**Amendments to the Drawings:**

REMARKS

Application No. 10/726,964  
Amendment dated April 5, 2005  
Reply to Office Action of January 7, 2005

FIG. 2

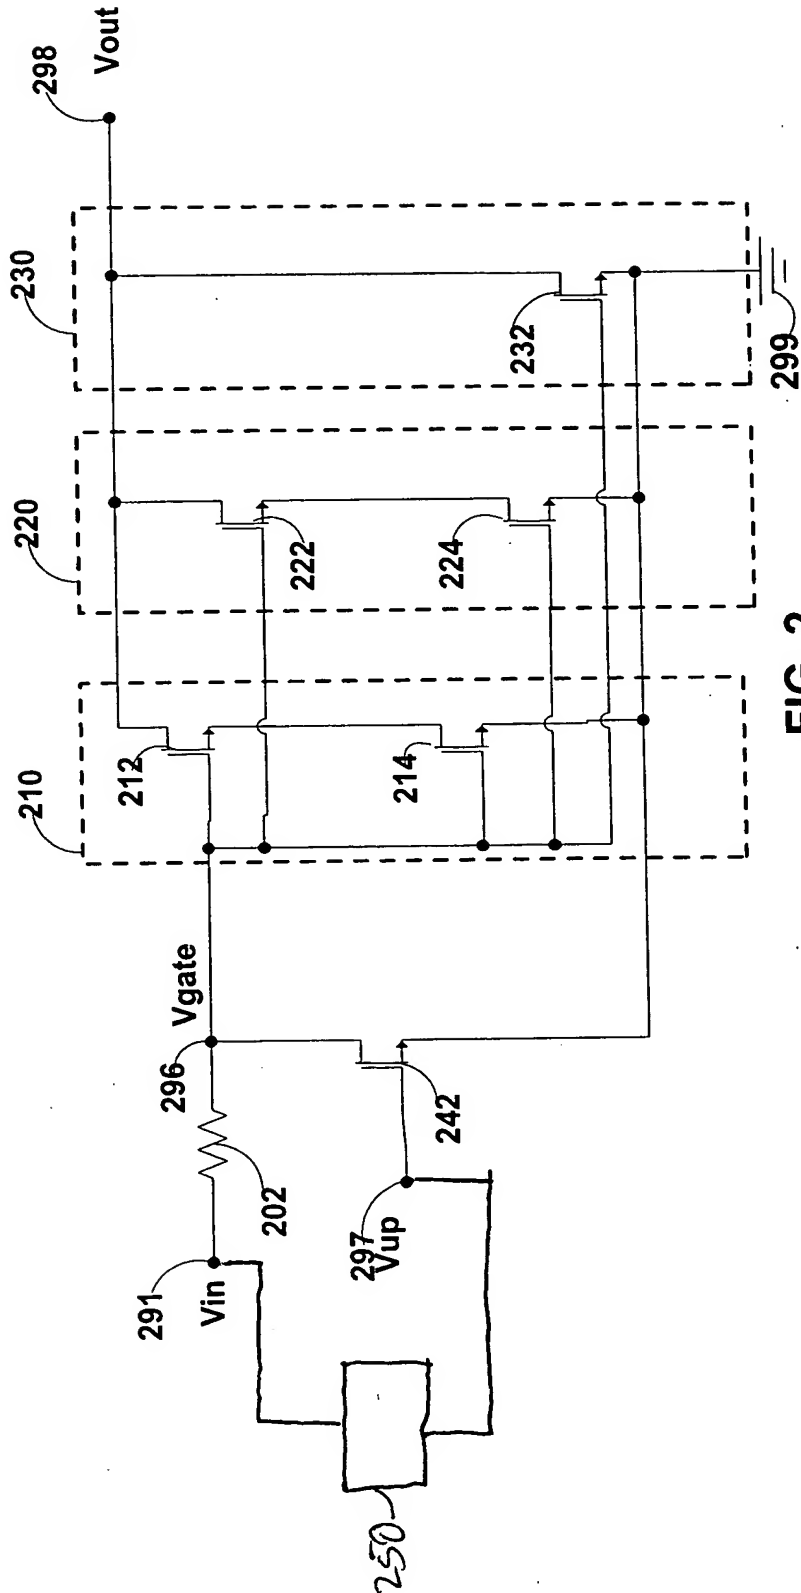
FIG. 2 has been amended to correct inadvertent errors made by mistake and without deceptive intent. FIG. 2 has been amended to correlate with the specification and the originally filed claims. No new subject matter has been added. FIG. 2 has been amended such that the logical  $V_{UP}$  voltage on control node 297 is provided by the output of a comparator circuit 250 that compares the input voltage on node 291 with a minimum voltage required by a particular load. Support for the amendments appear in the specification at page 10, lines 6-11 and original claim 25, for example.

The drawings have been objected to under 37 C.F.R. § 1.83(a) for not showing every feature of the invention specified in claim 25.

The drawings have been objected to under 37 C.F.R. § 1.83(a) for not showing every feature of the invention specified in the claims, in particular the limitation of a comparator circuit of claim 25. The Examiner's objections are respectfully traversed.

As described above, FIG. 2 has been amended to correct inadvertent errors made by mistake and without deceptive intent. FIG. 2 has been amended to correlate with the specification and the originally filed claims. No new subject matter has been added. FIG. 2 has been amended such that the logical  $V_{UP}$  voltage on control node 297 is provided by the output of a comparator circuit 250 that compares the input voltage on node 291 with a minimum voltage required by a particular load. Support for the amendments appear in the specification at page 10, lines 6-11, as amended, and original claim 25, for example.

Therefore, for at least the above reasons, FIG. 2 shows the limitation of a comparator circuit of claim 25. As such, applicants respectfully request that the objections of the drawings under 37 C.F.R. § 1.83(a) be withdrawn.
